Prepared for:
NSW Department of Education

Date:
14 January 2022

Response to Submissions Report (SSD-23330227)

John Palmer Public School

Figure 1 Community use of school facilities at JPPS (Figure 44 of the EIS)
Source: PTW Architects

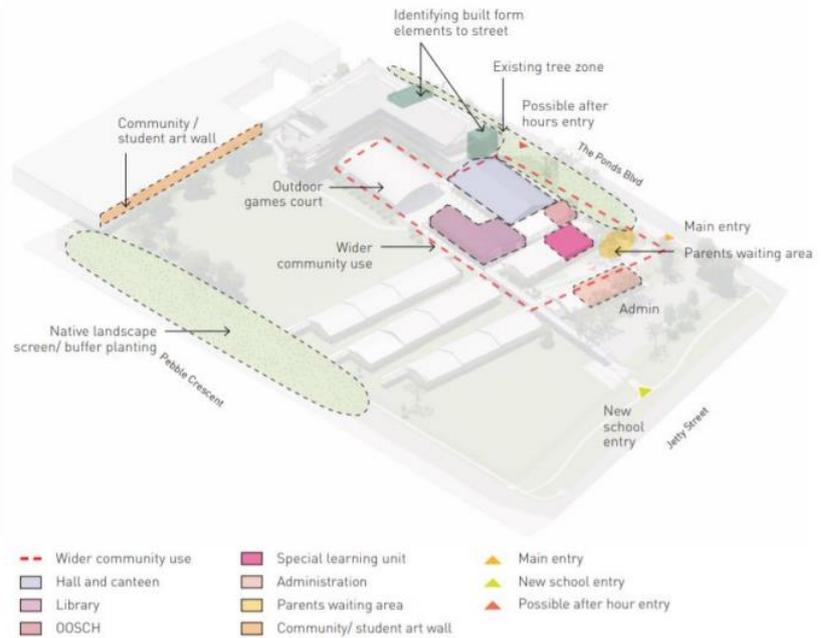
In this regard, Council has queried the area of the school dedicated to wider community use as shown in Figure 44 in the EIS (reproduced below at **Figure 1** for convenience). Council considers that there are additional potential activation opportunities that can take place through the program on the field as well as the sports court.

Although **Figure 44** of the EIS shows the area of the school dedicated to wider community use, nothing prevents the use of the sports court for further community activities, provided it is not contrary to the Public Private Partnership (PPP) agreement.

SINSW does not propose any changes to community use of school facilities. Notwithstanding this, it should be noted that this matter is not within the remit of SINSW due to the abovementioned PPP agreement. Therefore, the commercial and legal implications of additional community uses requires further consideration.

Figure 7 Detailed landscape plan showing changes to fencing at the north-east boundary of the site

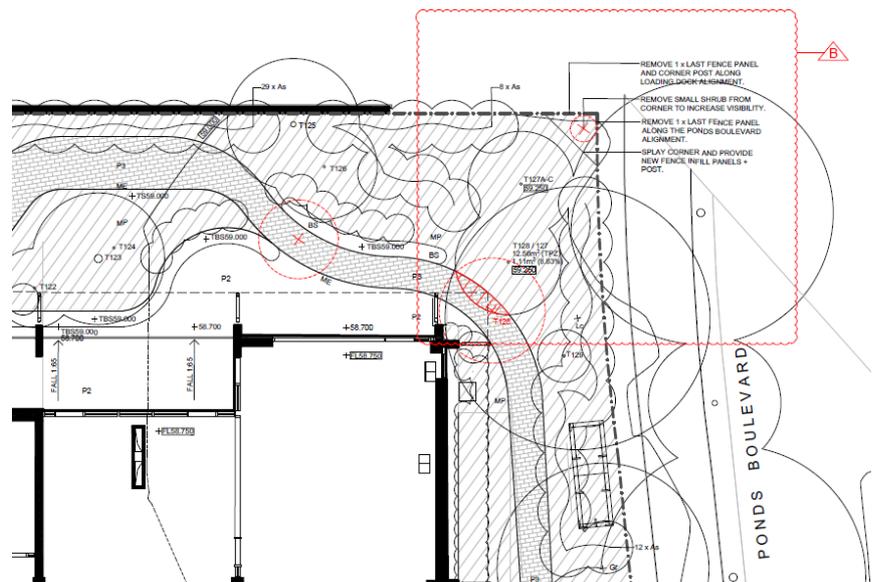
- **Pedestrian Safety** – Blacktown City Council have also raised concern regarding safety of pedestrians crossing the driveway of TPSC to the north of the site and recommend a splayed corner to improve pedestrian sightlines. Refer to **Figure 2** which illustrates the relationship of the fence adjacent to TPSC.

- **Pedestrian Safety** – Although TPSC followed the establishment of the school, to improve pedestrian safety at the north-east boundary of the school, the two corner panels of the fence will be splayed. To further improve sightlines, the landscaping within the new splayed corner will be removed. Refer to the revised landscape plans at **Appendix C** and extract at **Figure 7**.

Further, in response to concerns raised by Blacktown Council, the fence at the north-east boundary of JPPS has been reconfigured to create a splay that will improve sightlines for vehicles moving northbound and pedestrians approaching TPSC driveway.

Figure 9 Measurement locations
Source: AECOM Australia Pty Ltd

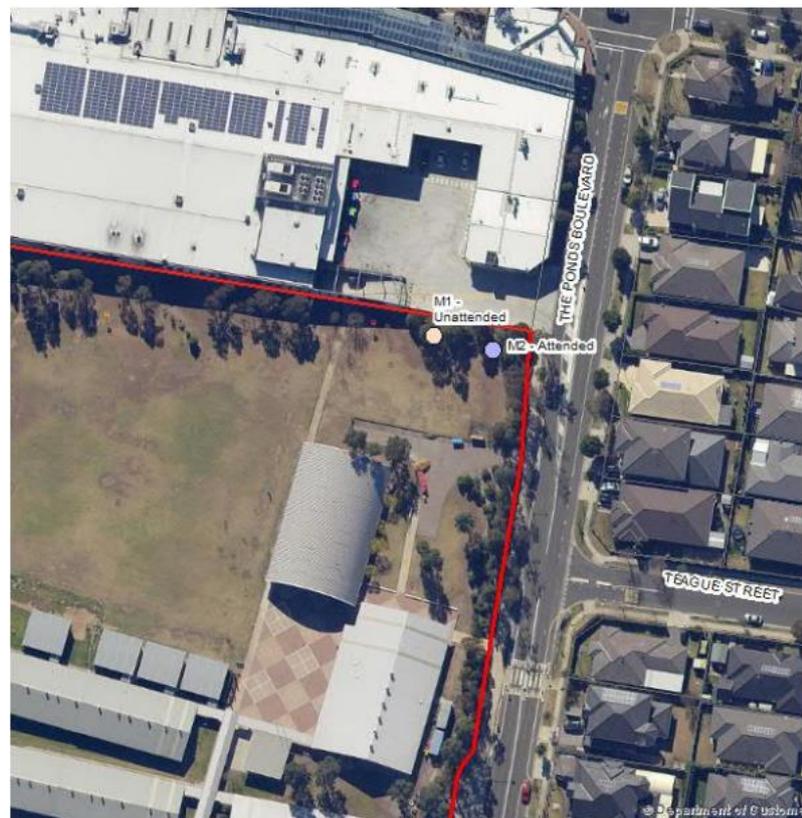
TPSC contends that given its proximity, classrooms and learning areas may be impacted by noise emissions from existing loading activities. While acknowledging the location of TPSC, the submitted Noise Assessment at **Appendix H** of the EIS does not consider the proximity of the existing loading dock and its impact of its operations on the proposed development.

TPSC loading dock is already subject to limited hours of operation. Concern is raised that, without any noise mitigation measures, the new learning areas and classrooms will be adversely affected by TPSC, thereby resulting in complaints against the TPSC and further restrictions being imposed on their loading activities.

- **Noise intrusion from adjoining uses** – An Acoustic Response Letter has been prepared by AECOM Australia Pty Ltd to address the noise related items received during exhibition, particularly the noise intrusion from adjoining uses such as the operations of TPSC. Refer to **Appendix F**.

To determine the existing noise levels from TPSC, noise monitoring was conducted at the approximate location of the proposed new building closest to TPSC. Refer to **Figure 9**. The noise logger was placed at the Location M1 between Thursday 16 December and Wednesday 22 December 2021. An attended measurement was also conducted between 1.45pm and 2.00pm on 22 December 2021, at M2 for a 15-minute period to understand the impact of various sources to outdoor areas.

Figure 12 Detailed landscape plan showing changes to vegetation surrounding the substation
Source: McIntosh and Phelps

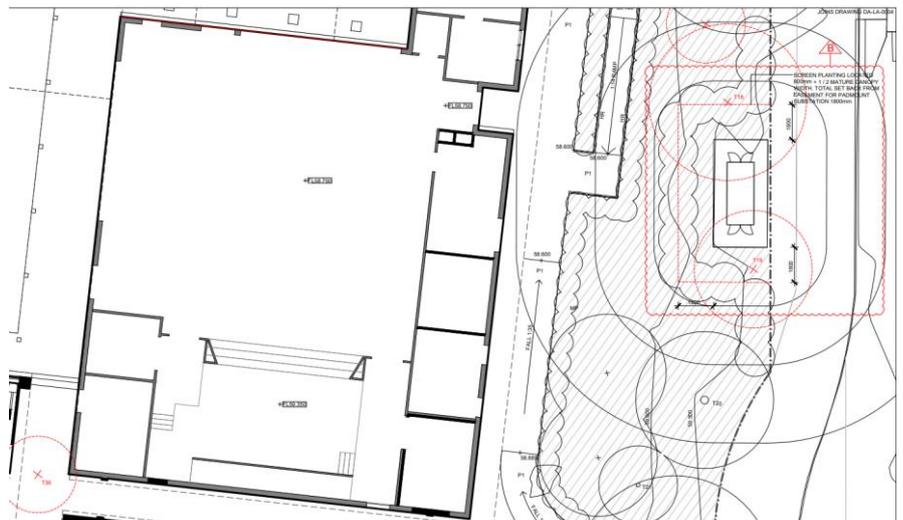
Furthermore, it is noted that Endeavour Energy have provided a submission which raises concerns regarding the proximity of screen planting around the padmount substation along The Ponds Boulevard frontage.

In relation to the screen planting around the padmount substation, the landscape design has been modified in response to the recommendations by Endeavour Energy. The screen planting around the padmount substation is now a minimum distance of 800mm plus half of the mature canopy width from the substation easement. All screen planting species have shallow / non-invasive root systems. Refer to the revised landscape plans at **Appendix C** and extract at **Figure 12**.
